## Unit Managers' Meeting: 300 Areas Remedial Action Unit/Source Operable Units

Meeting Minutes Transmittal/Approval  
300 Area Unit Managers' Meeting  
Remedial Action and Waste Disposal Unit/Source Operable Unit  
3350 George Washington Way, Richland, Washington  
September 2002

## 618-5 STAGING PILES

### STAGING PILE LOCATIONS

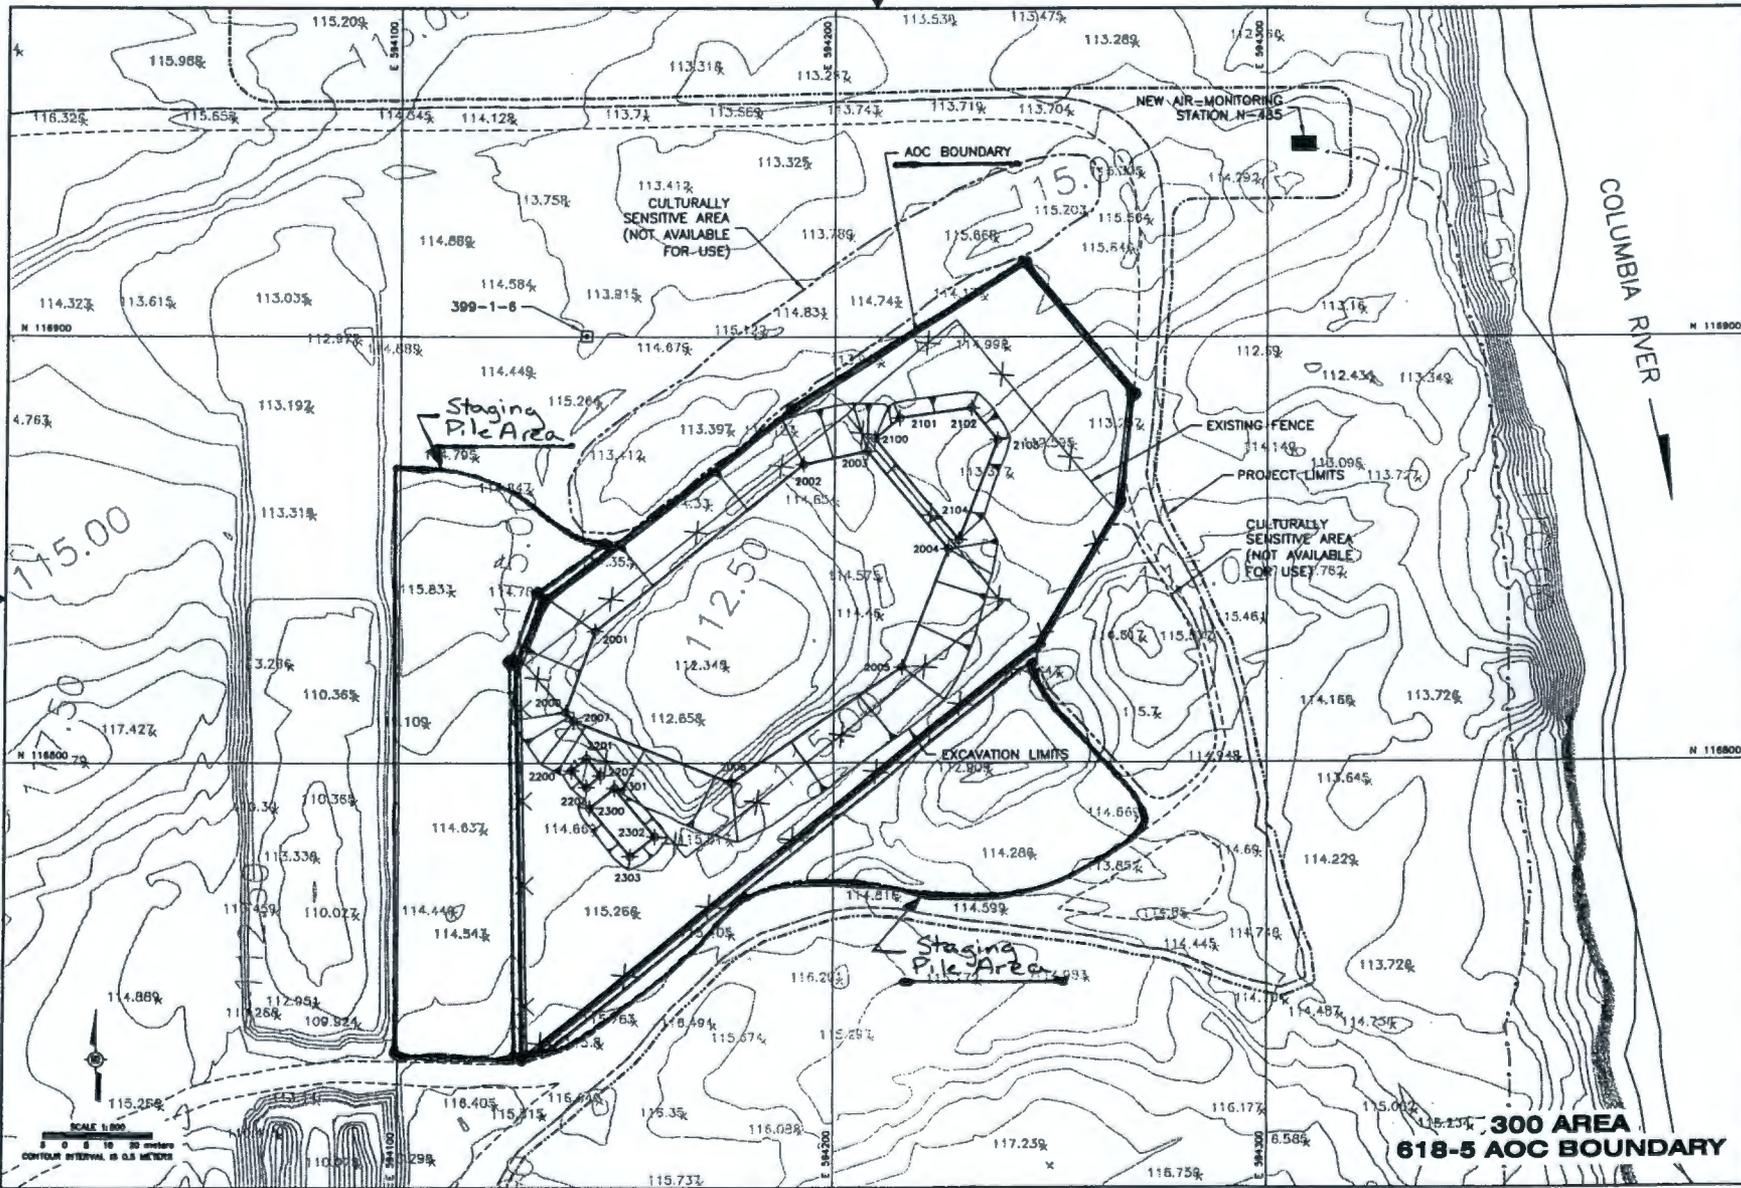
staging pile areas to the area west and to the south of the 618-5 Burial Ground area of contamination (AOC) (Attachments 5-7) as required by the RDR/RAWP. EPA approval is required before using the staging pile area to the south of the AOC. In addition, EPA requested information on the public participation requirements. At a minimum it was recommended that the RDR/RAWP and UMM minutes, which are part of the administrative record, serve as the mechanism of having information available to the public (Attachment 8). However, it was also recommended that a remedial design fact sheet be prepared as discussed in the Superfund Guidance. EPA stated that the RDR/RAWP was sufficient and the Superfund Guidance also allows EPA the discretion to not require a fact sheet since the basis of staging piles constitutes a minor or insignificant change.

The basis for use of the staging pile area versus expansion of the AOC to cover the same area was also discussed. EPA expressed a preference for expansion of the AOC and stated they would contact EPA Region 10 for a basis to authorize expansion. This information is expected by the end of September. In the meantime, it was agreed that operations would proceed using the staging pile area. The remedial action subcontractor plans to use the area west of the AOC initially.

With this sentence added, I concur with everything in the "controls" section except the first sentence of the last bullet. My issue is that the purpose of the biased and random sampling is not to verify "compliance with cleanup objectives," but rather to verify "that the staging area is clean (i.e., has not been contaminated through use) and therefore does not require any long-term institutional controls." This is especially relevant to this location as it has been certified as "clean closed" with respect to chemicals via the RCRA closure process.

Also, with regard to the e-mail Jack sent out that describes the rationale for why we are using the staging pile regulations as opposed to simply expanding the area of contamination, I am curious to hear Bechtel's interpretation of how the requirements outlined in 264.554 for "closing" a staging pile sited in an uncontaminated area (which cites sections 264.258(a) and 264.111) and public notification are being met as well.

That being said, I have no problem with you proceeding to use the designated staging pile areas using the language contained in the controls section of this draft (with the exception noted above). If we modify the rationale or other language in the RDR/RAWP as a result of the other questions I have asked, it will not affect my approval of the procedure you have outlined in this attachment (except as noted).

Attached is a map of the staging pile areas for the 618-5 burial ground. There are two primary staging areas; one west of the 618-5 burial ground and one south of the 618-5 burial ground. Within the staging pile areas, staging piles will be placed that are within the contiguous property of 300-FF-2 OU and adjacent to the 618-5 Area of Contamination (AOC).

- The staging pile area will be surrounded with a minimum of a 15-centimeter (6-inch) berm to control run-on/run-off control prior to use.
- The staging pile area to the west of 618-5 burial ground will be utilized first and EPA approval will be obtained prior to using the area to the south of 618-5 burial ground.
